ADDENDUM NO. 3

Perry Township Schools:
Southport High School Addition & Renovation Phase 1 (Activity Center Addition &
Wrestling/Center Plant Renovation)
971 E. Banta Road
Indianapolis, IN 46227

ADDENDUM NO. THREE

DATE OF ADDENDUM: February 12, 2026

Drawing Sheet Title: FLOOR PLAN – FIRST FLOOR – UNIT R

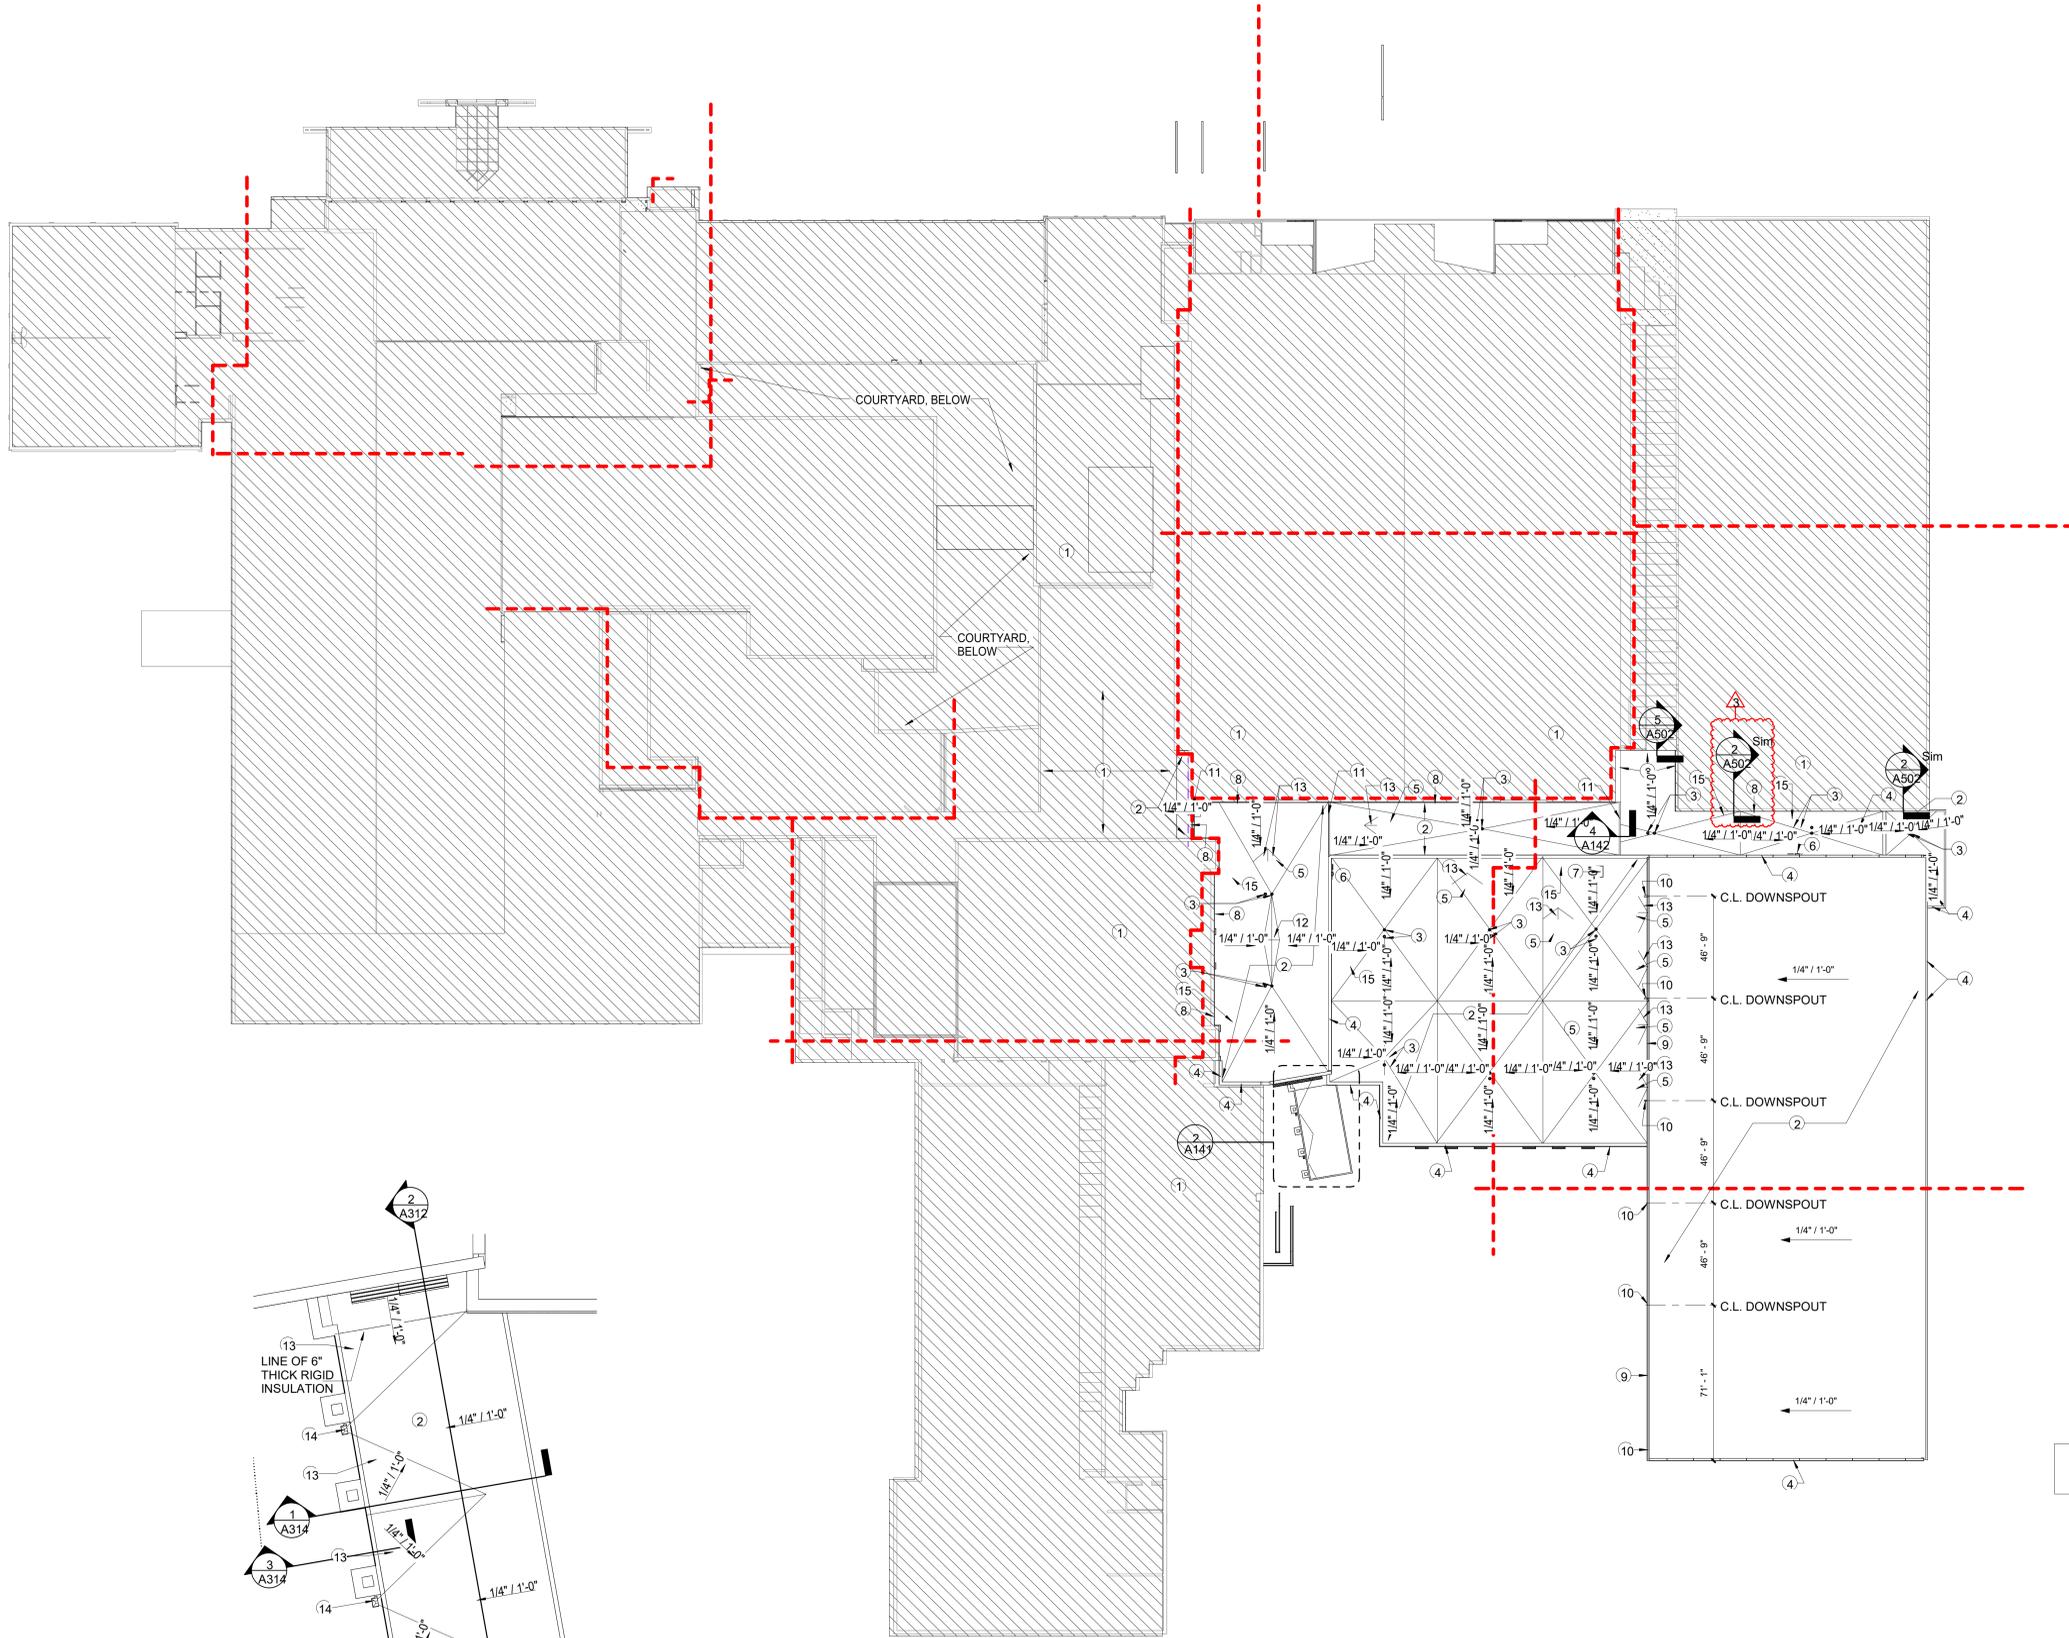
- Add callout location of the SF 08 on the plan.

Drawing Sheet Title: EXTERIOR ELEVATIONS

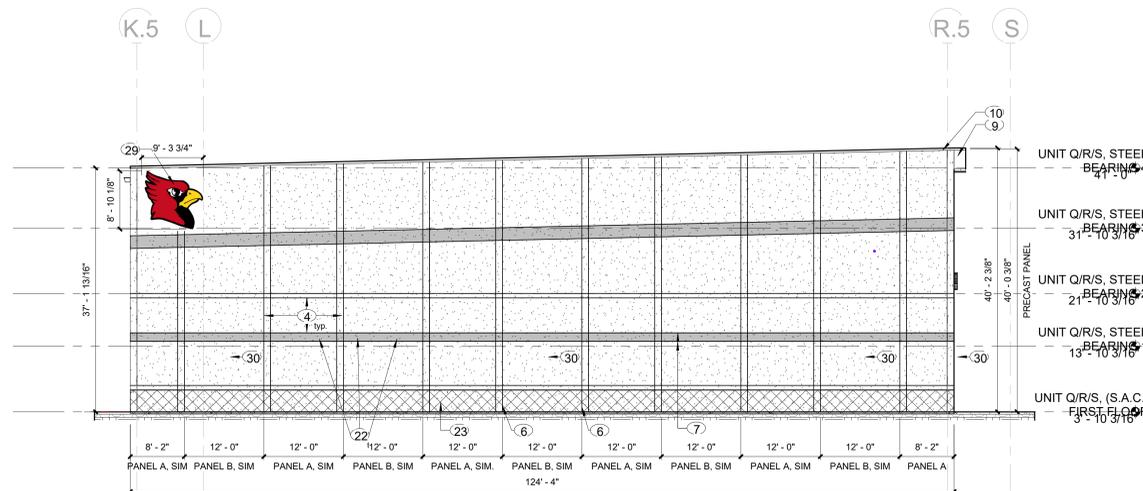
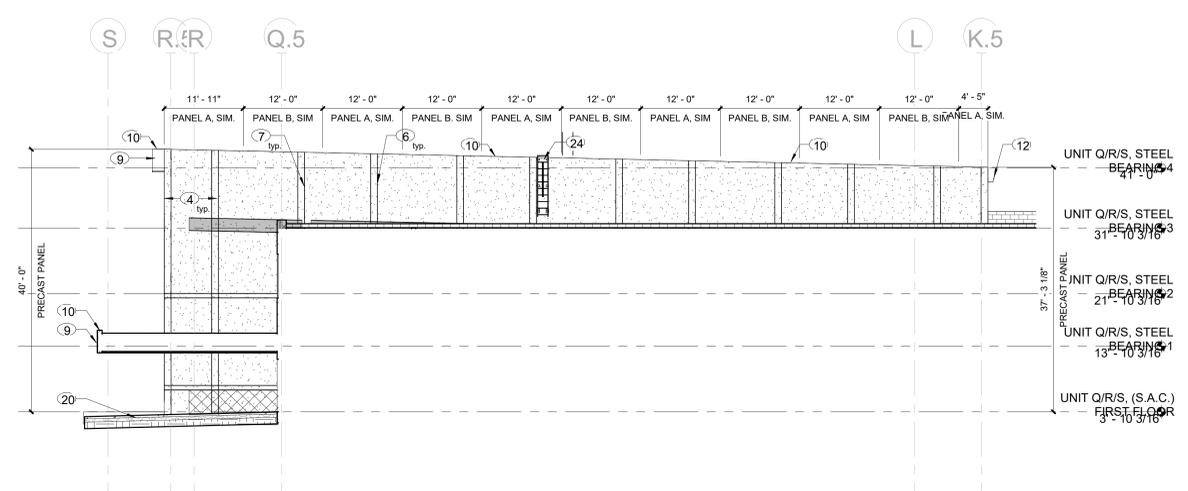
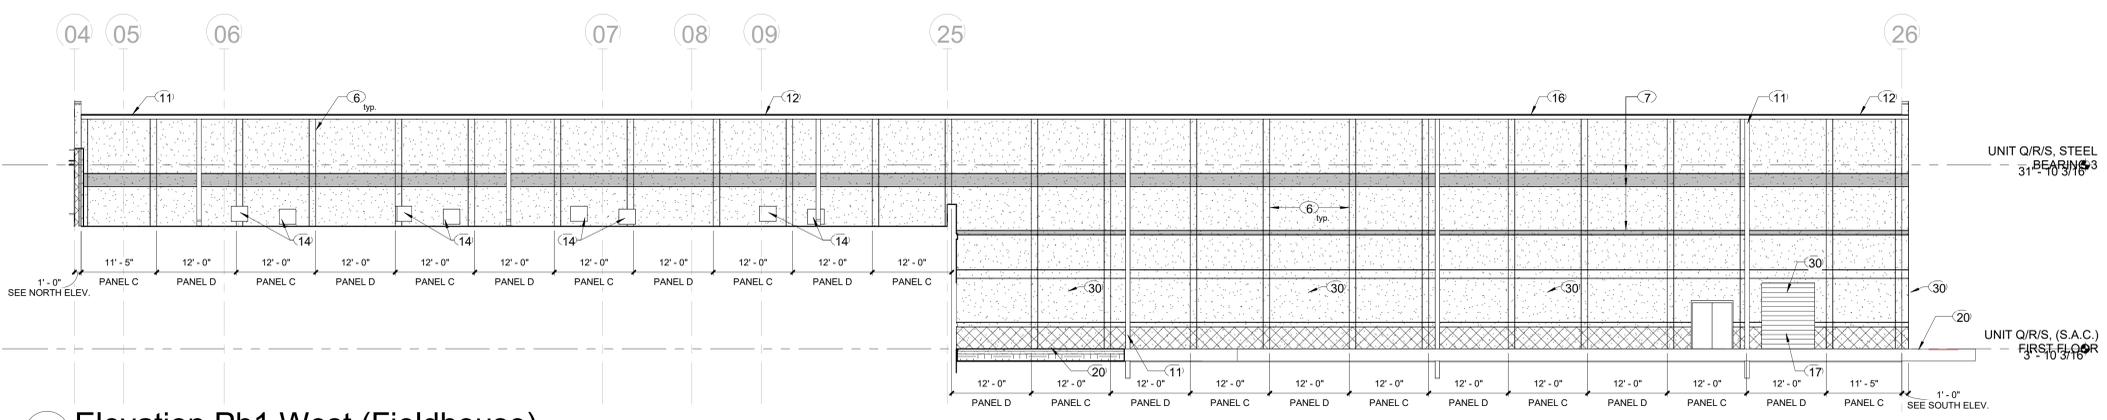
- Modify elevation 3 to clarify mullions in the translucent wall system.
- Modify elevation notes 8 and 9.

Drawing Sheet Title: ELECTRICAL LIGHTING FIRST FLOOR PLAN – UNIT Q

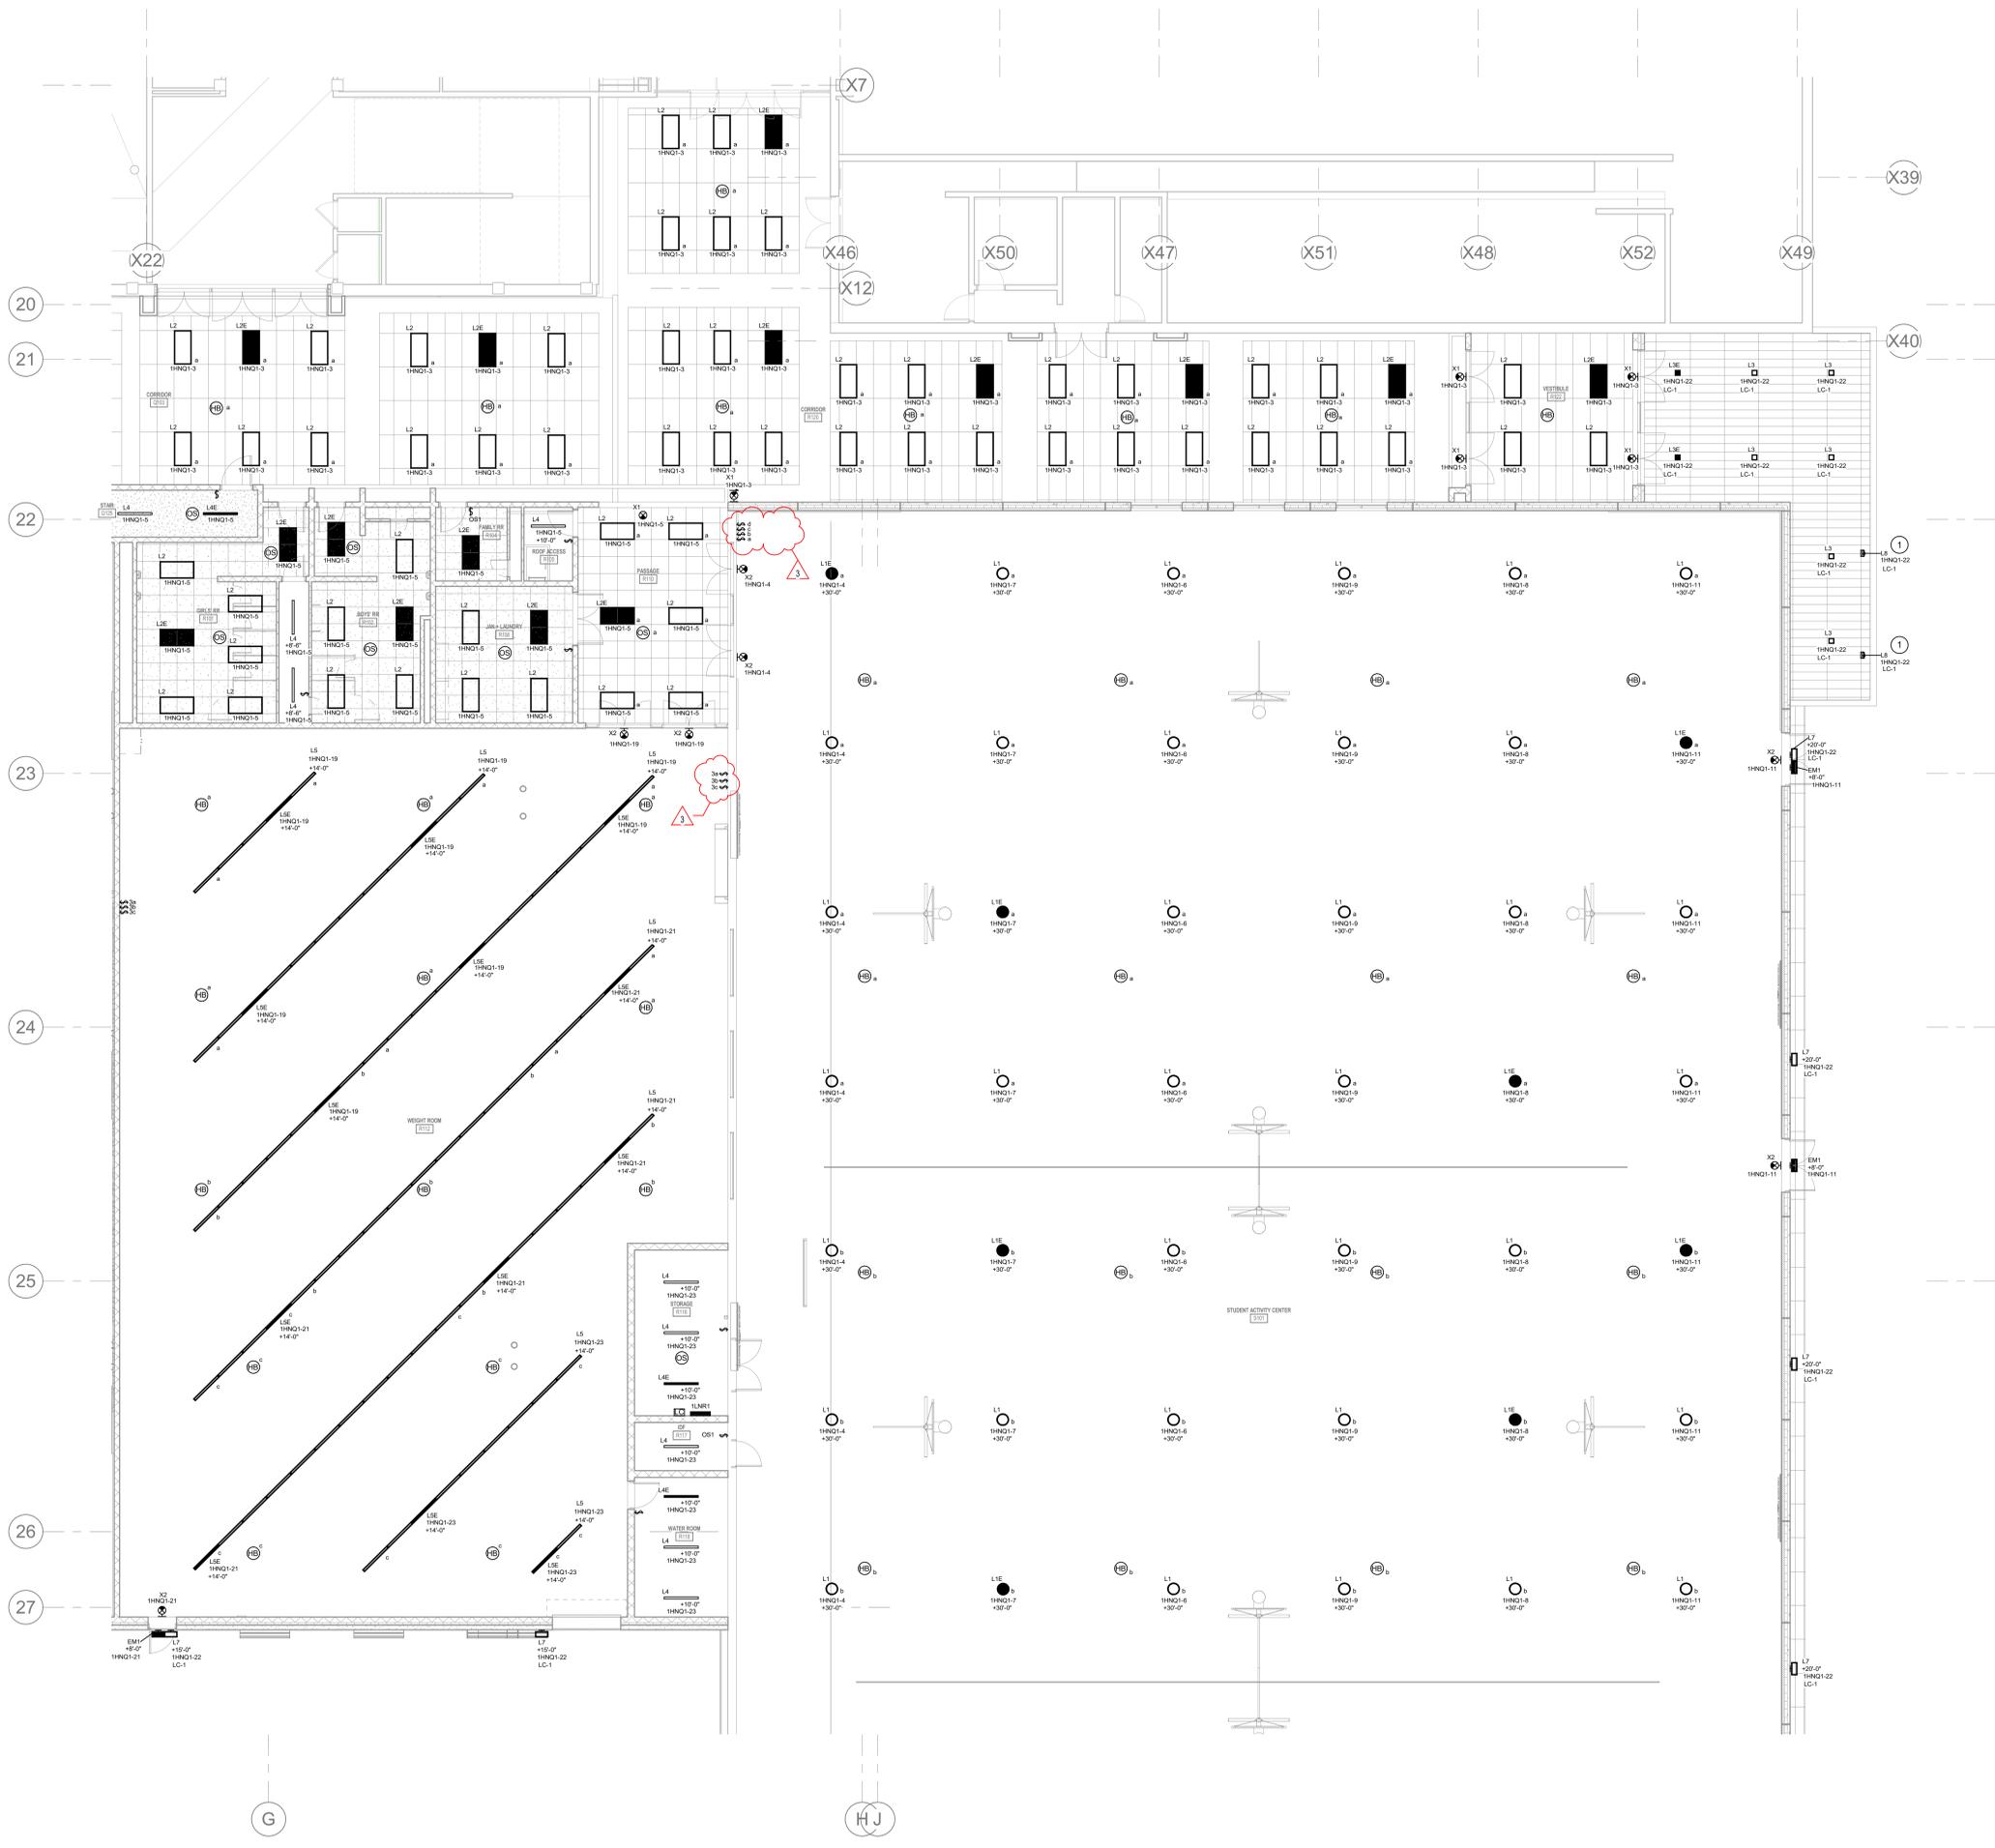
Change: Changed lighting types and layouts in the auditorium lobby.
Change: Removed dimming and modified occupancy sensing in the coaches offices.

Change: Removed dimming from the wrestling room.
Change: Updated lighting in storage room Q123.
